UNITED STATES PATENT AND TRADEMARK OFFICE

10/563,993

Office Action Summary	Application No. 10/563,993	Applicant(s) REICHENBACH ET AL.	
	Examiner PUNAM PATEL	Art Unit 2855

DETAILED ACTION

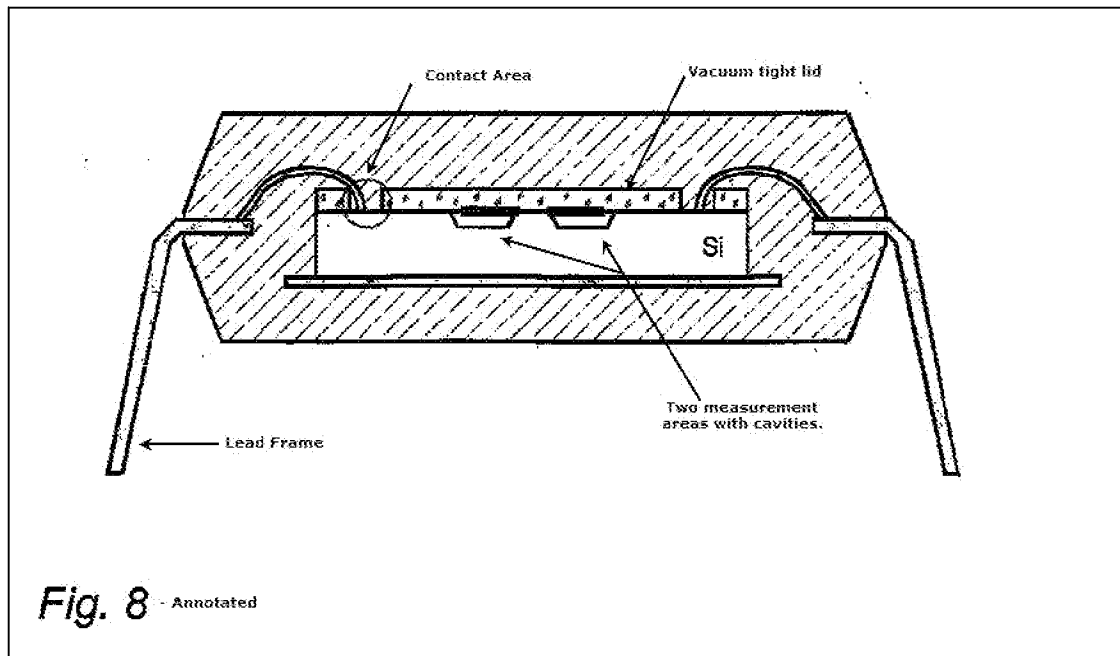
With respect to Claims 19, 20, and 31, Landsberger discloses an apparatus comprising:
a measurement chip (the Si substrate) with a first and second measurement area/structure formed thereon (the cantilever structures);

the measurement areas being offset in a lateral direction;

a cap chip fastened to the measurement chip in a connecting area;

intermediate space (the cavity) between the cap chip and the measurement chip; and

at least one contact area not covered by the cap chip. See Annotated Fig. 8 below;

With respect to Claim 21, 25, and 27, Landsberger discloses two contact areas formed on opposing sides of the measurement chip and left exposed by the cap chip. See Annotated Fig. 8 below.

With respect to Claim 35, Landsberger discloses a lead frame, a housing, and wire bonds. See Annotated Fig. 8 below. (Compare to Applicant's Fig. 8).
